## PRODUCT/PROCESS CHANGE NOTICE (PCN)

PCN #: <b>MM1809-01</b> Date: September 26, 2018 Product Affected: 9FGV1006AnnnLTGI (8) 9FGV1006Q5nnLTGI (8) (Refer Attachment II for the affected part#) Date Effective: December 26, 2018	<b>MEANS OF DISTINGUISHING CHANGED DEVICES:</b> <input checked="" type="checkbox"/> Product Mark      Change in the top mark and orderable part# <input type="checkbox"/> Back Mark <input type="checkbox"/> Date Code <input type="checkbox"/> Other
---	---

### ATTACHMENT I - PCN # : MM1809-01

**PCN Type:** Die revision change

Figure 1 9FGV1006A/9FGV1006Q5 Spread Off to Spread On Transition

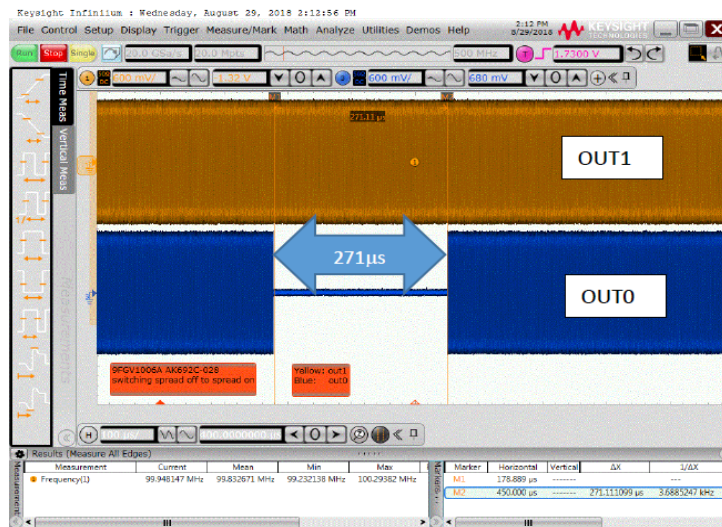
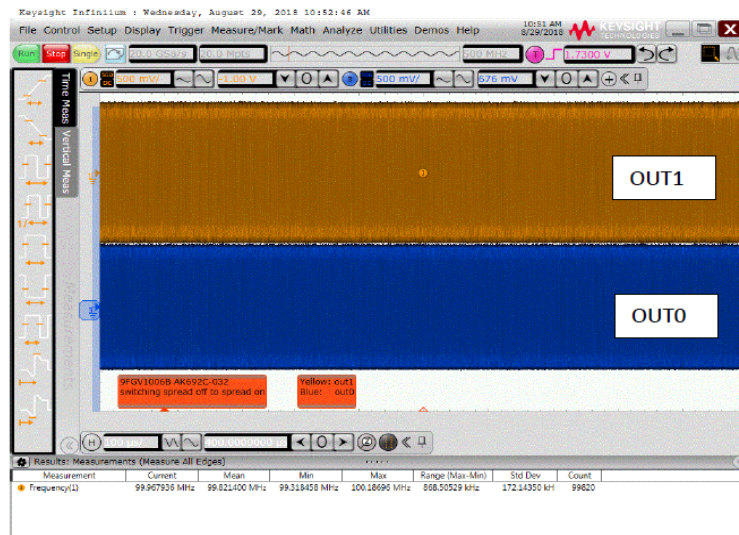
This notice is to advise our customers that a quality improvement was made to the part numbers as listed in Attachment I to resolve the issue of OUT0 to stop for approximately 200 to 270uSec when turning Spread on or Spread off.

Figure 2 9FGV1006B/9FGV1006BQ Spread Off to Spread On Transition
